4		3
ITEM	CONNECTOR PART NO.	DESCRIPTION
1	See Table 1	ZR CONNECTOR
2	UL1571, 28 AWG	GREY

SCALE	<div><div></div><div>1</div></div> <div><div>4</div><div>1</div></div>		Electrical Specifications
				1: 1			Current: 0.7A AC/DC
				DIMENSIONS			Voltage: 50V AC/DC
				All dimensions are in MM with a tolerance of ± 5.0 unless otherwise specified.			DESCRIPTION
4	Revised description from overall to inside length	6/13/2024	SP	DRAWN BY STEVEN PILKINGTON	1.5 mm Pitch ZR Standard Catalog Assembly - 2" Inside Length – Pin out: 1 to N		
3	Length tolerance revised from ± 3.0 to ± 5.0	6/13/2024	SP		ASSEMBLY PART NO.		
2	Revised connector from Green (8M) to Black (8K) version	6/13/2024	SP		SEE TABLE 1		
1	Add electrical specifications	6/27/2018	SP		DRAWING NO.		
REV.	DESCRIPTION	DATE	BY	CHECKED BY JUSTIN BAKER	GAM-019		DATE 2/26/2016

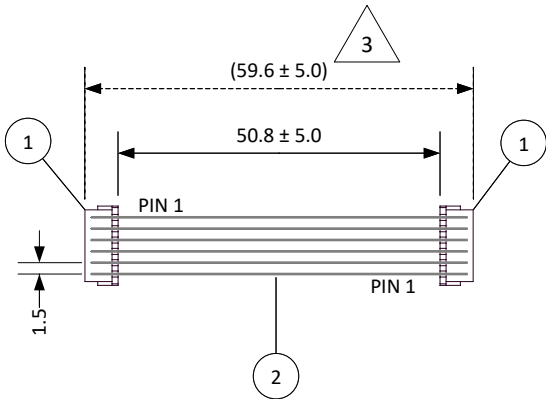
The connector part number has changed from the Green (M) version to the Black (K) version for UL approved material. There will be no change to the assembly part number. Contact JST if a Product Change Notice is required.
